YARRA CITY COUNCIL
Internal Development Approvals Committee
Agenda

1.1 PLN17/0693 - 210 Alexandra Parade East, Clifton Hill - Development of the land with a six-storey building (plus basement) for dwellings, and alterations to a road access in a road zone.

1. This report provides Council with an assessment of Planning Permit Application PLN17/0693 which affects land at 210 Alexandra Parade East, Clifton Hill and recommends approval, subject to conditions.

Shadows cast at 9am at the Equinox (September 22nd)

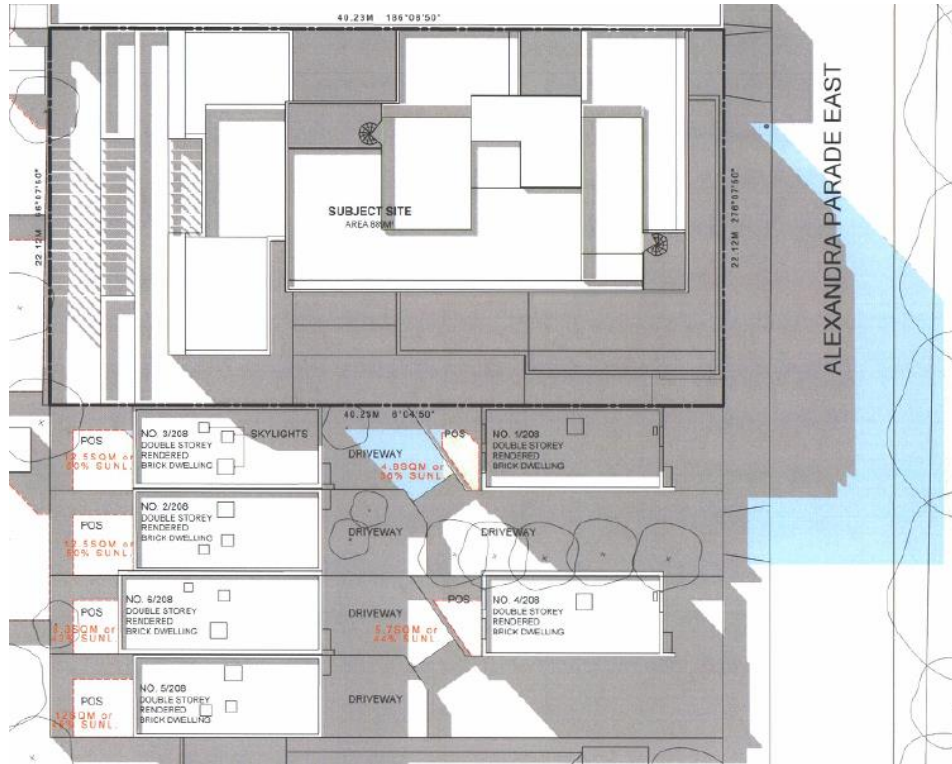
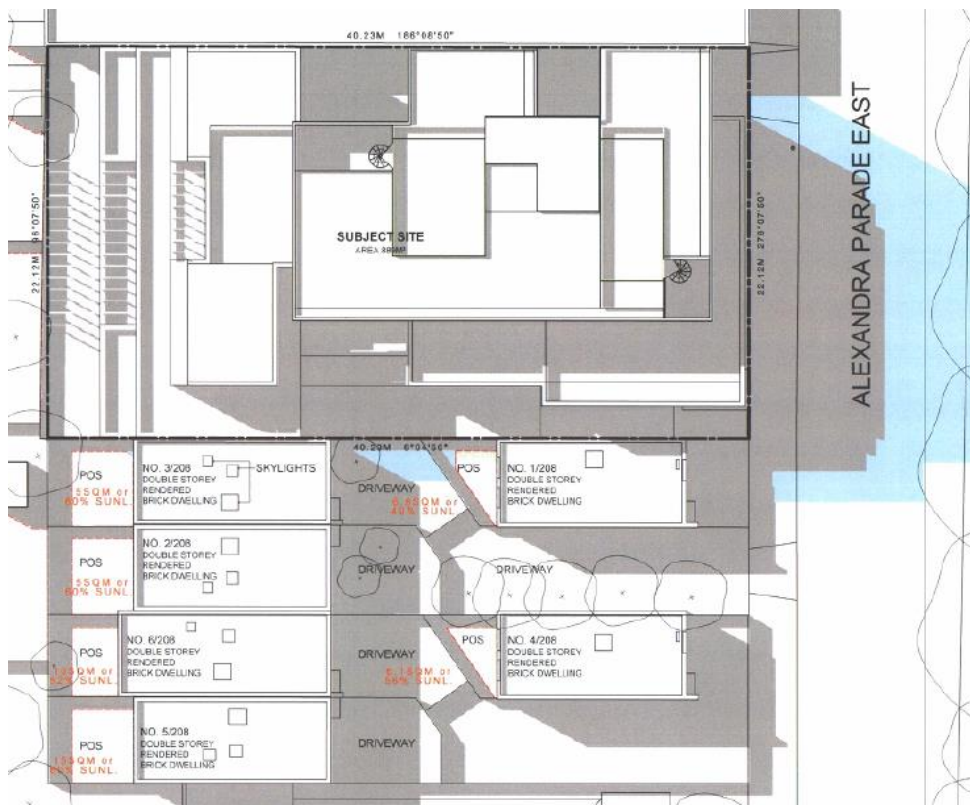
161. Due to the orientation of the land, the proposal will cast shadows to the west in the morning, to the south in the afternoon and to the east in the afternoon. The plans have increased the setbacks of the development at the upper levels from the northern boundary as a means of mitigating some of the shadow impact cast into three of the dwellings to the west (i.e. property no's 1/208, 3/208 and 4/208 Alexandra Parade East from the original scheme between 9am and 11am at the Equinox (September 22). The shadow diagrams below indicate that the majority of additional shadow would now be cast over the driveways associated with the adjoining townhouses, with a marginal shadow impact and increase only evident between 9am and 11am into the private open spaces of the two dwellings most immediate to the development:
